Rezoning Transportation Analysis

Petition Number: 2020-120

General Location Identifier: Tax ID (02962106)

Date	Description
09-11-20	First Review
10-19-20	Second Review

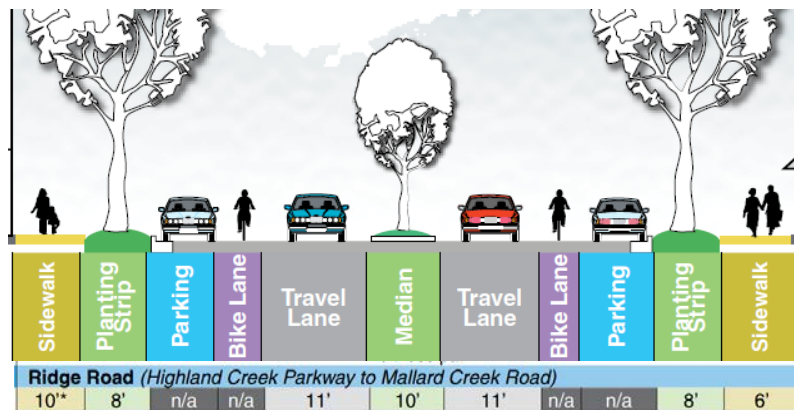
- a. ~~**Ridge Road:** Match the future location of curb and gutter to the Prosperity Hucks Area Plan cross section, as shown below. Pavement widening should occur asymmetrically to the south of the proposed petitioner's site, since the parcel across Ridge Road to the north of the Redwood Ridge Road Subdivision is a mitigation site for I-485 construction and is protected by a conservation easement. Please refer to SDRMFR-2019-00041 - Redwood Ridge Road to tie in the proposed streetscape into the approved Redwood Ridge Road Subdivision plans. The cross section from the Prosperity Hucks Area Plan may be modified to substitute the 10-ft sidewalk for a 12-ft multi-use path, in accordance with Charlotte BIKES.~~

Label and dimension the curb and gutter from the centerline for each road.

REDWOOD CHARLOTTE
RIDGE ROAD NC PL1 LLC
PARCEL: 02972118
ZONING R-8MF(CD)

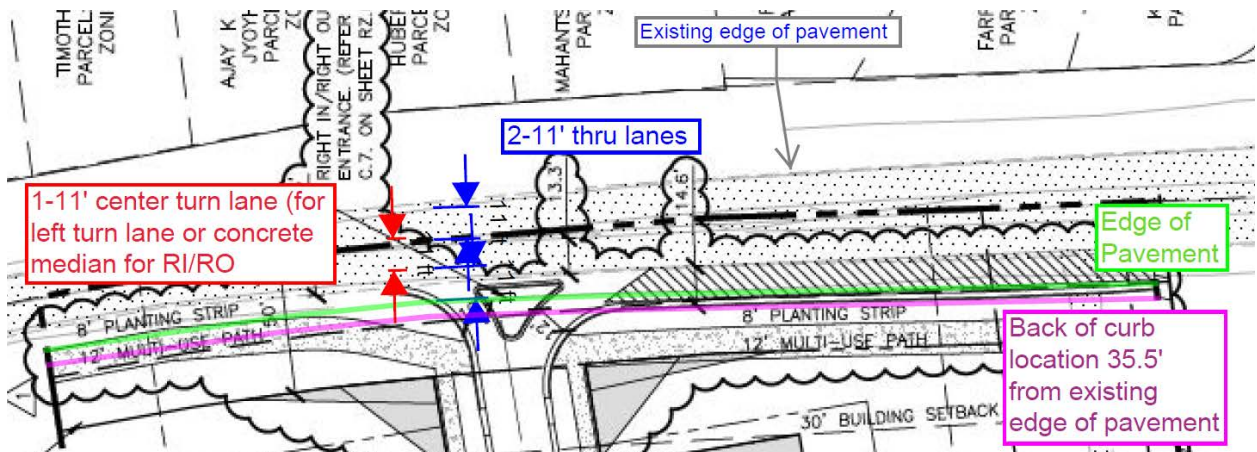
2. ~~**Traffic Study** A Traffic Impact Study is not necessary for the complete review of this petition due to the site generating less than 2,500 daily trips. If during the permitting process the site generates more than 2,500 daily trips, then a traffic study will be required.~~
3. ~~Revise the site plan and conditional note(s) to include the street network approved within the recently approved by right subdivision project: **SDRMFR-2019-00041 - Redwood Ridge Road**, to confirm that proposed Street B will connect to future Lilac Grove Drive.~~

Show the Redwood subdivision plan street network

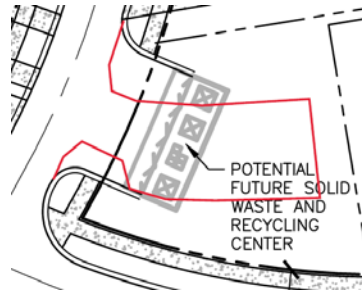
8. **New comment (site plan dated 10.12.2020):** The petitioner should revise the site plan and conditional note(s) to update the proposed curb line, 8-ft planting strip, and 12-ft multi-use path, according to the redlines shown below. After additional review of the approved plans for SDRMFR-2019-00041 - Redwood Ridge Road, the development is providing an 11-ft center turn lane, as opposed to the 10-ft center turn lane that was recommended within the Prosperity Hucks Area Plan.
